Corridor 16-24

Black Rock Desert to Oregon

Figure 3. Map of Conflict Areas in Vicinity of Corridor 16-24

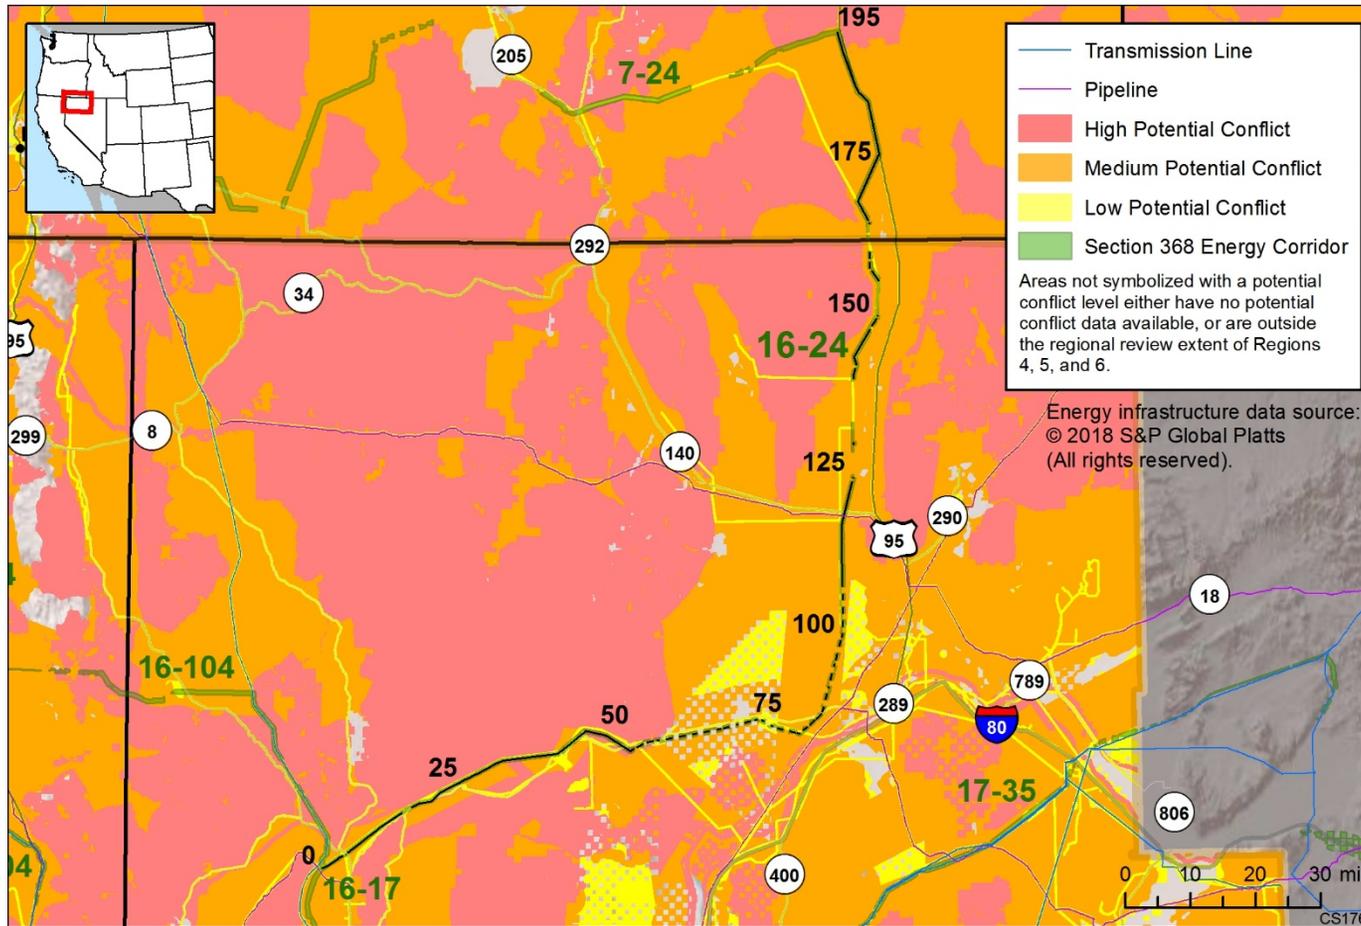
Selenite Mountains WSA and the corridor are adjacent – The RMP does not prescribe ROW avoidance or exclusions for areas adjacent to WSAs.	MP 12 to MP 15	Under the Wilderness Act (1964), a WSA must be managed as Wilderness pending final determination by Congress. It is highly unlikely that utility ROWs could be approved in Wilderness Areas or WSAs.	The corridor location appears to best meet the siting principles. The corridor is collocated with an existing transmission line, minimizing impacts on the WSA. Because the corridor is not located in the WSA development and management inside of the corridor would not be affected. However, the Agencies could consider shifting the corridor to the north at this location to further minimize potential impacts on the WSA.
California NHT and the corridor intersect – The RMP does not prescribe ROW avoidance or exclusions for areas within the California NHT. The corridor crosses a high potential segment (Nobles Trail Junction to Granite Peak).	MP 21	The corridor crosses and does not follow the California NHT, although it parallels the California NHT for four miles in areas with broad visibility. The National Trails System Act, as cited in the Comprehensive Plan for	NHT high potential segments may not be compatible with the corridor’s purpose as a preferred location for energy infrastructure. However, the intersection with the trail is generally perpendicular to the corridor and cannot be avoided. At this location the corridor is collocated with a

<p>BLM Jurisdiction: Winnemucca and Surprise Field Office Agency Land Use Plan: Black Rock Desert-High Rock Canyon Emigrant Trails NCA and Associated Wilderness, and Other Contiguous Lands in Nevada ROD and RMP (2004)</p>			
Black Rock Desert - High Rock Canyon Emigrant Trails NCA and the corridor intersect – The corridor is one of two designated corridors within the NCA.	MP 33 to MP 35 (intersects)	The area of the NCA that is intersected by the corridor is a fingerlike extension that crosses the	The corridor is narrowed near the Black Rock Desert-High Rock Canyon Emigrant Trails NCA to minimize impacts. There is no opportunity to avoid the NCA extension area

VRM Class II areas and the corridor intersect - The RMP does not prescribe ROW avoidance or exclusions for VRM Class II areas. . The objective of VRM Class II designation is to retain the existing character of the landscape.	MP 46 to MP 59		<p>Areas with the VRM Class II designation may not be compatible with future overhead transmission line development in this section of the corridor that does not have existing infrastructure. The Agencies could consider changing the VRM designation, or shifting the corridor to the south between MP 44 and MP 50 to collocate it with an existing 60 kV transmission line and avoid the VRM II area. Between MP 50 and MP 59 the corridor could be shifted to other federal lands to avoid the VRM Class II area, but it would then not be collocated with the existing transmission line.</p>
<p>BLM Jurisdiction: Vale District Office Agency Land Use Plan: Southeastern Oregon RMP (2002)</p>

Lands with wilderness characteristics and lands with undetermined status for wilderness characteristics intersect and are adjacent to the corridor.	MP 167 to MP 195	At MP 167 the corridor parts from an existing 115 kV transmission line to join I-95 at MP 175. From MP 175 to MP 195 the corridor is collocated with	The corridor location appears to best meet siting principles. The corridor is partially collocated with I-95, and, for the most part, the corridor cannot be shifted to avoid the lands with wilderness characteristics because

VRM Class I area is adjacent to the corridor – The VRM Class I area is the Bowden Hills WSA. The RMP does not prescribe ROW avoidance or exclusions for areas adjacent to VRM Class I areas.	MP 192 to MP 195		The corridor location appears to best meet the siting principles. The corridor is collocated with I-95, minimizing impacts on the VRM Class I area. Because the corridor is not located in the VRM Class I area development and management inside of the corridor would not be affected. However, the Agencies could consider shifting the corridor to the west at this location to further minimize potential impacts on the VRM Class I area.
Bowden Hills WSA and the corridor are adjacent – The RMP does not prescribe ROW avoidance or exclusions for areas adjacent to WSAs.	MP 192 to MP 195	Under the Wilderness Act (1964), a WSA must be managed as Wilderness pending final determination by Congress. It is highly unlikely that utility ROWs could be approved in Wilderness Areas or WSAs.	The corridor location appears to best meet the siting principles. The corridor is collocated with I-95, minimizing impacts on the WSA. Because the corridor is not located in the WSA development and management inside of the corridor would not be affected. However, the Agencies could consider shifting the corridor to the west at this

<i>BLM Jurisdiction: Vale District Office</i>			
<i>Agency Land Use Plan: Oregon GRSB ROD and ARMPA –March 2019</i>			
GRSB GHMA (ROW avoidance area) and the corridor intersect – The 2019 ARMPA did not make changes to GHMA in Oregon; designated utility corridors in GHMA may be available for utility ROWs with special stipulations.	MP 160 to MP 161, MP 167 to MP 169, and MP 191 to MP 195	RFI comment: corridor traverses a large area of priority GRSB habitat that provides critical habitat connectivity for GRSB populations in Malheur and Harney Counties. Due to the configuration of priority GRSB habitat in this region, acceptable modifications to reroute this corridor and avoid GRSB impacts would be unlikely. Re-route or exclude new infrastructure ROWs and avoid all new energy infrastructure development within GRSB PACs (12% overlap). Use full mitigation hierarchy to avoid, minimize, and compensate	ROW avoidance areas are not compatible with the corridor’s purpose as a preferred location for infrastructure. In some locations, it may be possible to shift the corridor to avoid or decrease the GHMA intersections while still collocating with the existing infrastructure. In other locations, the GHMA encompasses a broad area on both sides of the corridor that cannot be avoided.

CORRIDOR 16-24 REVIEW			
POTENTIAL COMPATIBILITY ISSUES or CONCERNS TO EXAMINE	MILEPOST (MP)¹	STAKEHOLDER INPUT and OTHER RELEVANT INFORMATION	POTENTIAL RESOLUTIONS BASED ON SITING PRINCIPLE ANALYSIS²
		<p>corridor traverses a large area of PHMA that provided critical habitat connectivity for GRSG populations in Malheur and Harney counties. Due to the configuration of PHMA habitat in this region, acceptable modification to reroute this corridor and avoid GRSG impacts would be unlikely. The Agencies should delete this corridor.</p> <p>Comment on abstract: recommend shifting the corridor along MP 165 to MP 195 to collocate with the existing transmission line to the west to avoid and/or minimize new impacts to GRSG core and low-density habitats (PHMAs) in favor of collocating in an area where impacts are already realized.</p>
